**ADDENDUM
NO. 01**

July 31, 2024

Renovation of Fall Creek Intermediate School
12011 Olio Road
Fishers, IN 46038

1 ENLARGED - MECHANICAL ROOM PLAN
 1/4" = 1'-0"

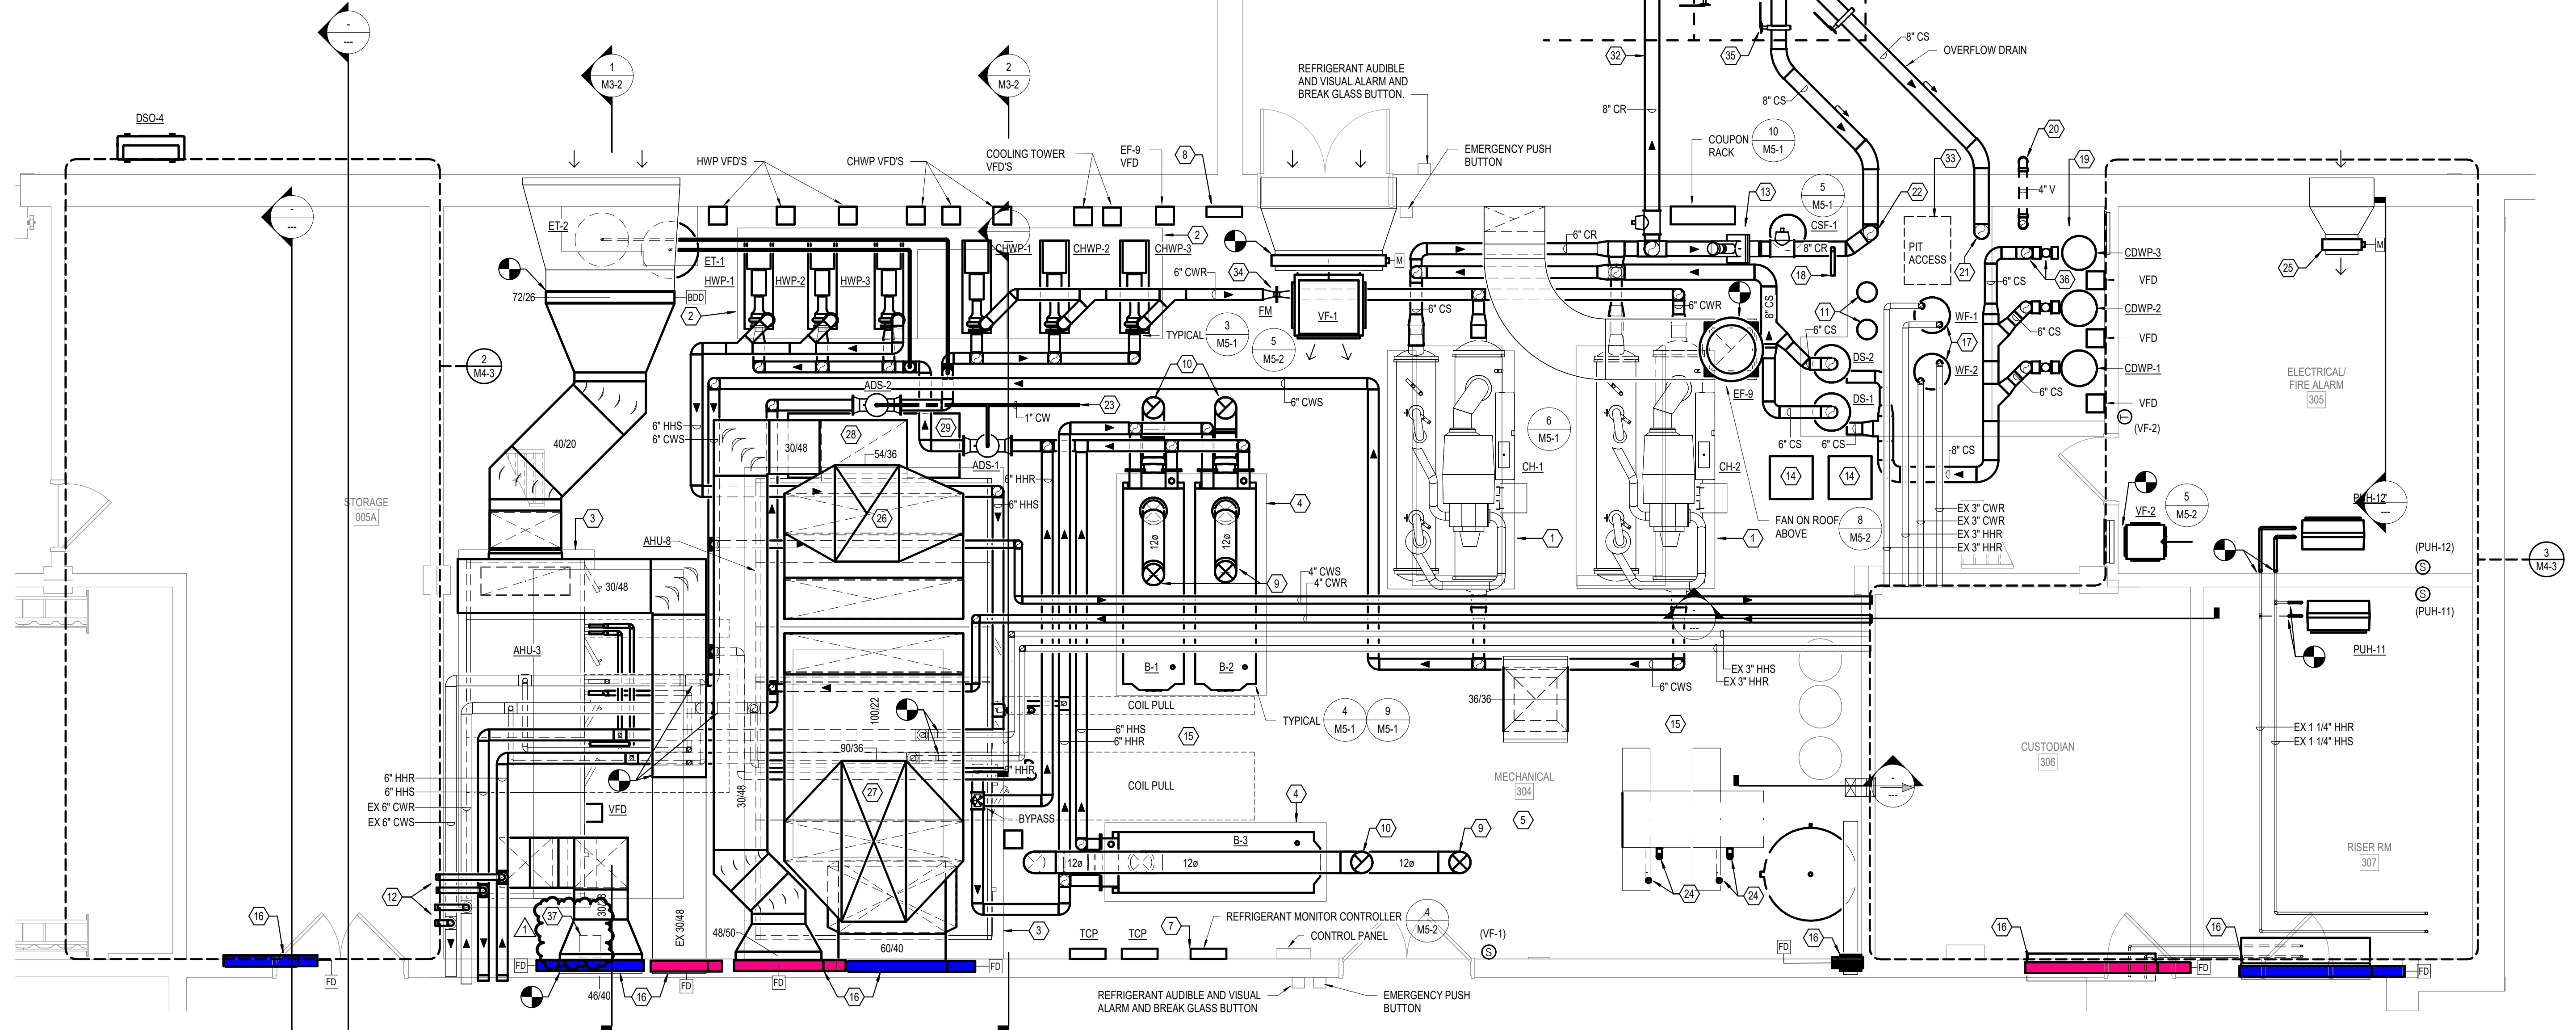
Sheet M4-3 ENLARGED MECHANICAL PLANS

1. Added plan note #37, 38 & 39.
2. Added low voltage controls transformers.

CONSTRUCTION DOCUMENTS
 07.12.2024
 W&J JOB NO. 23055
 DRAWN BY EAG
 DRAWING NAME
TECHNOLOGY DETAILS
 DRAWING NO.
T5-5

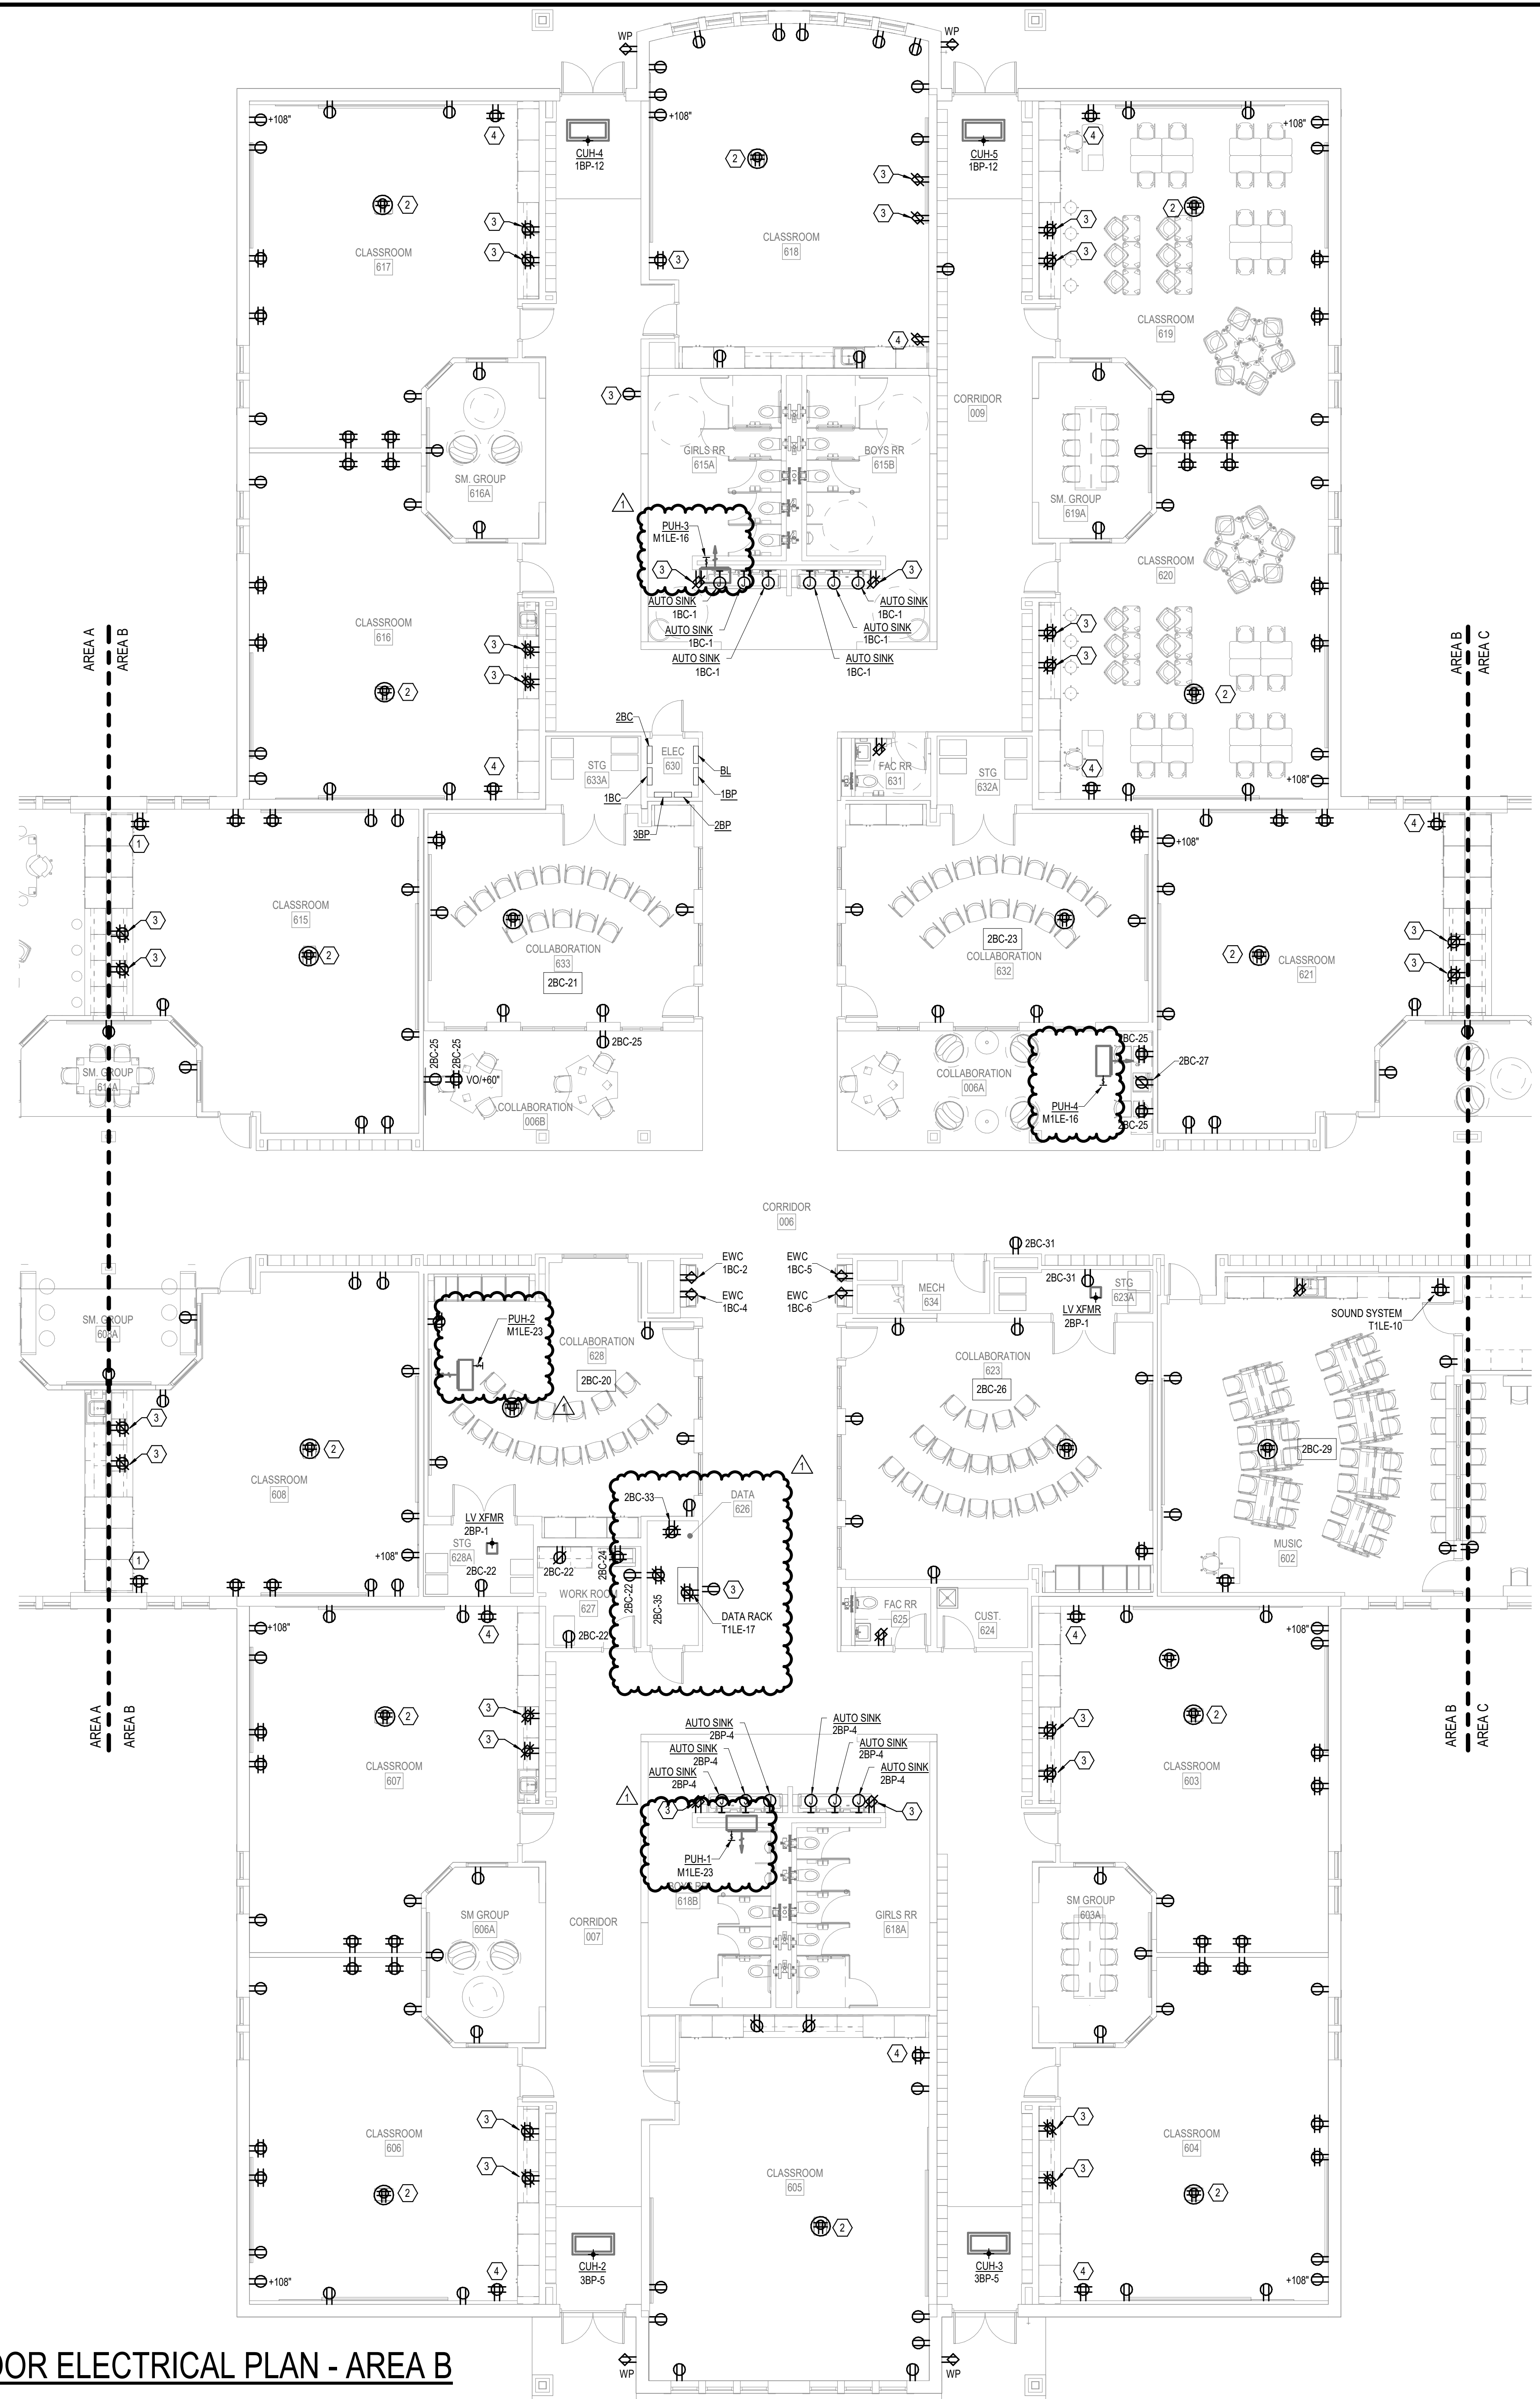
Sheet T5-5 TECHNOLOGY DETAILS

1. Revised gymnasium video equipment part number.

CONSTRUCTION DOCUMENTS
07.12.2024
W/J JOB NO.
23055
DRAWN BY
MHS
DRAWING NAME
**FIRST FLOOR
ELECTRICAL PLAN -
AREA B**
DRAWING NO.
EP1-2

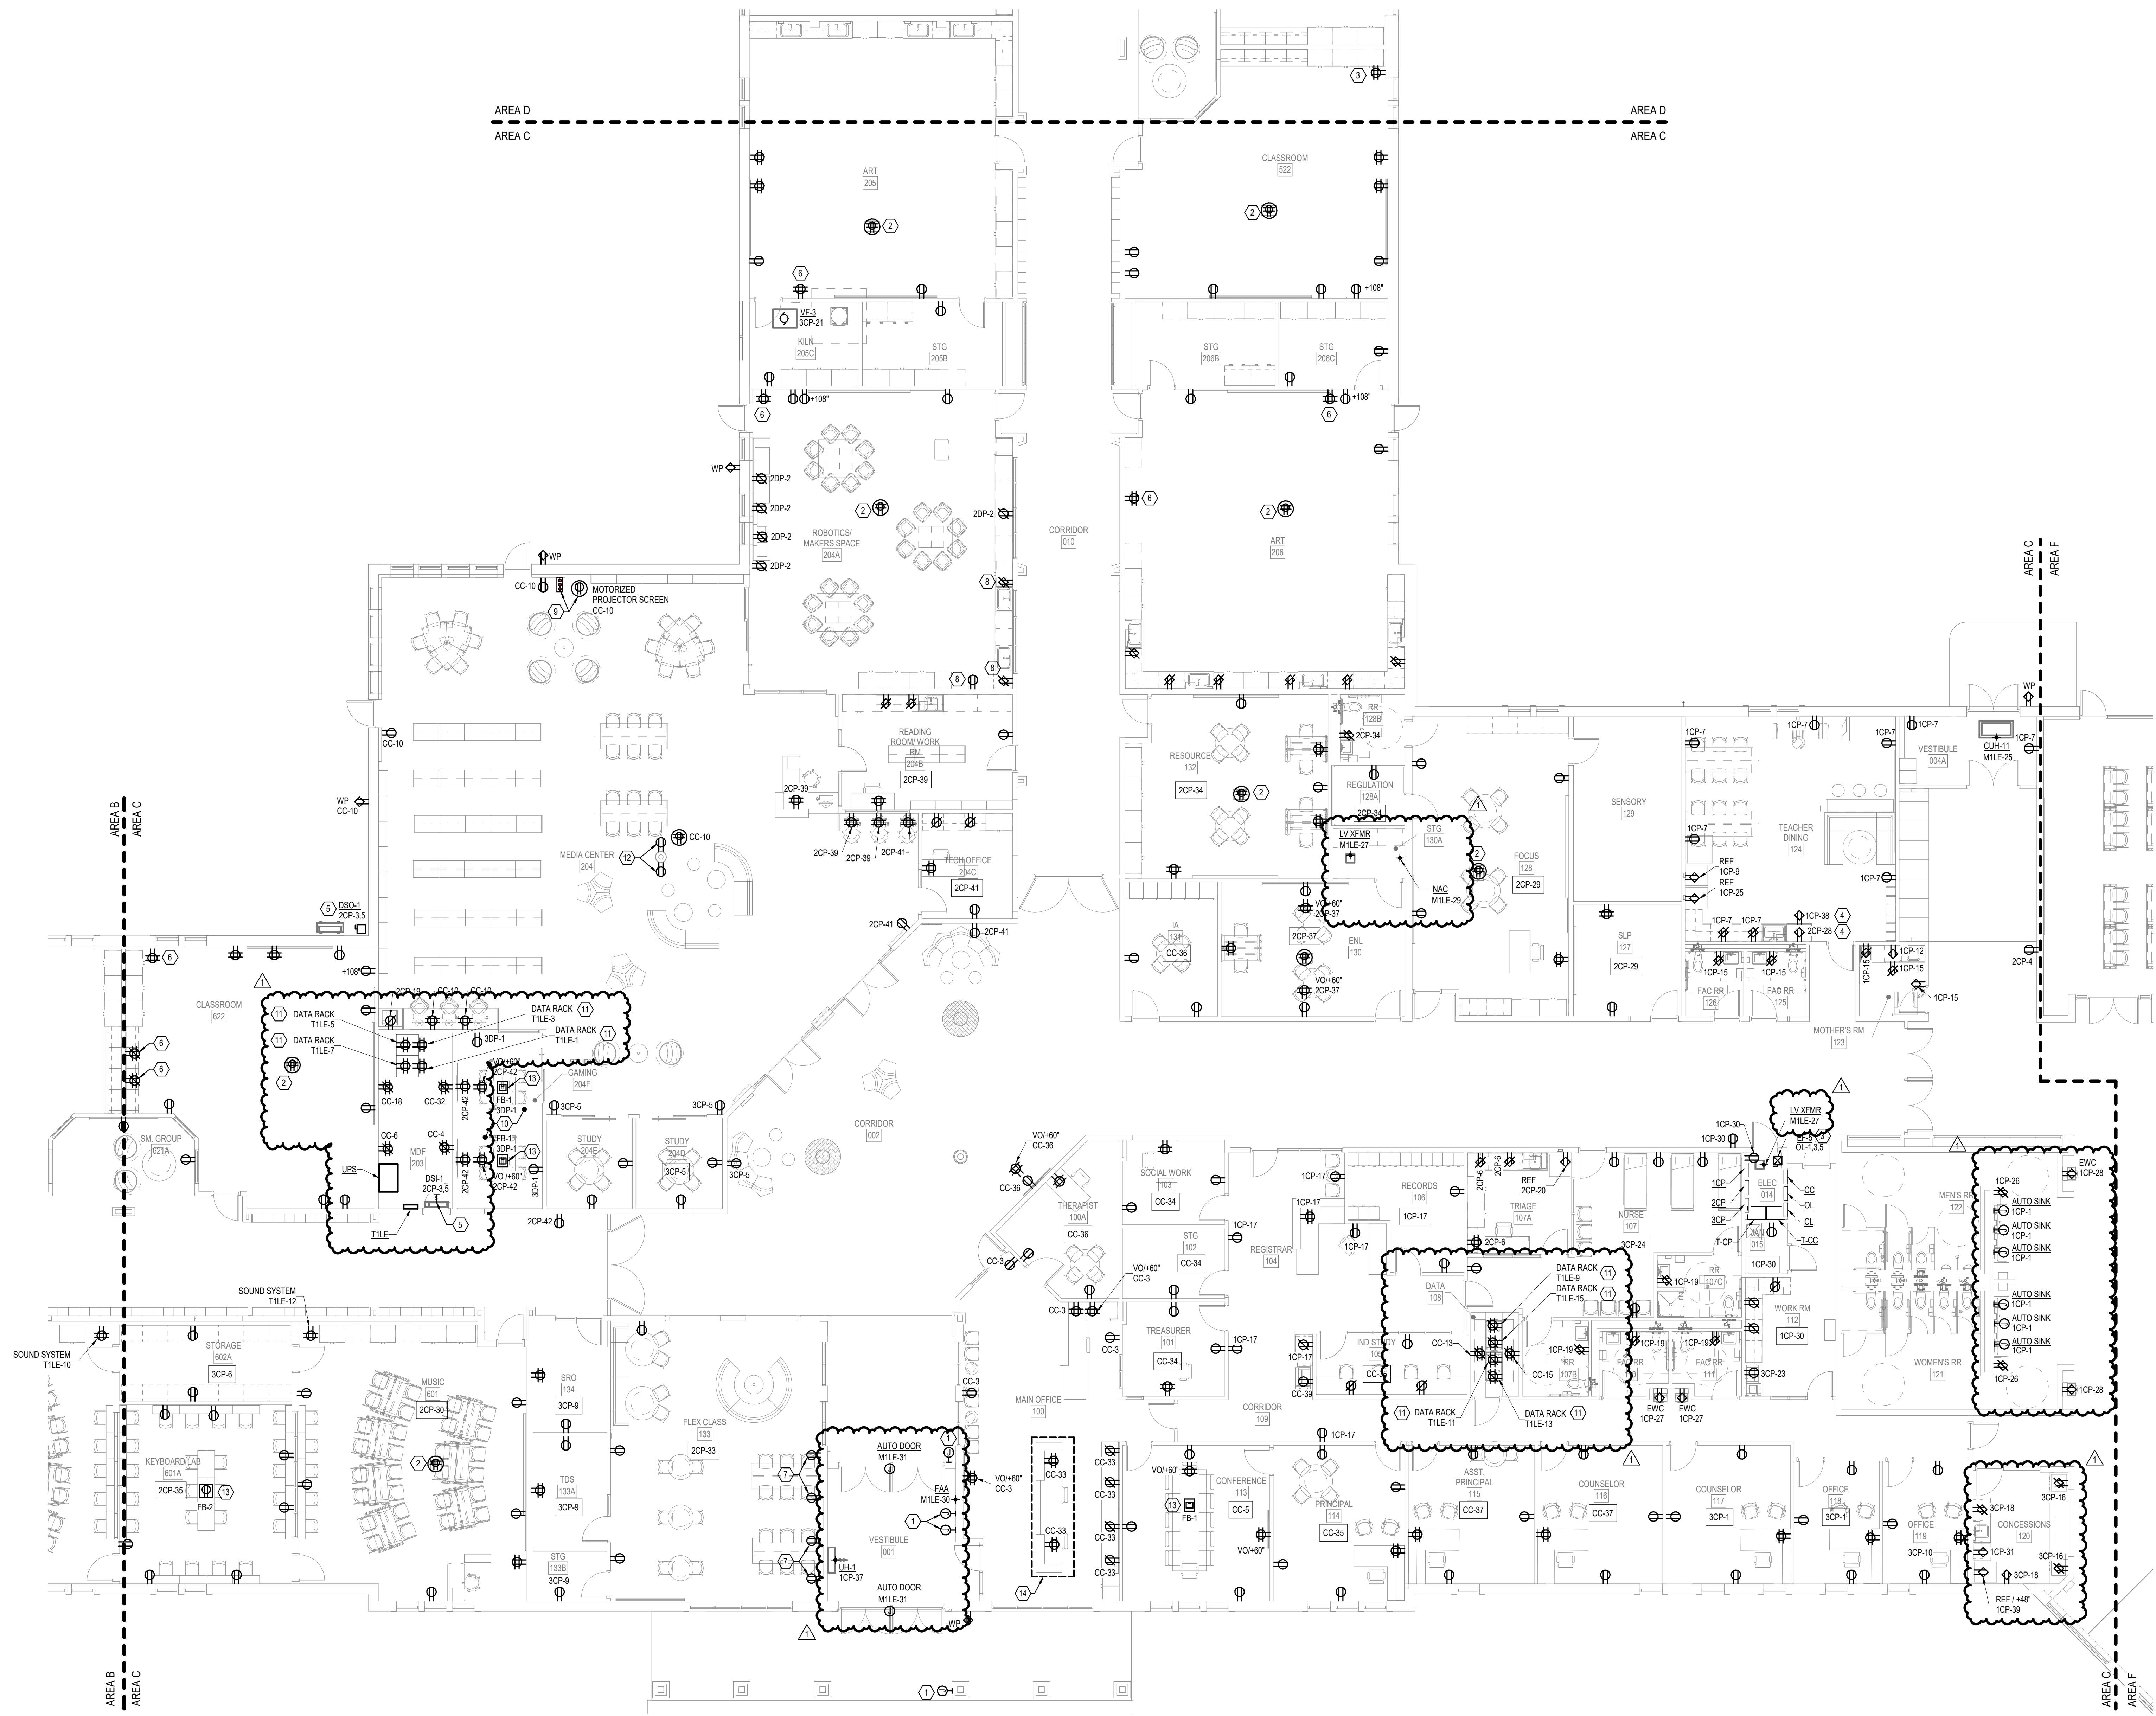
Sheet EP1-2

1. Revised circuit numbers for equipment shown.
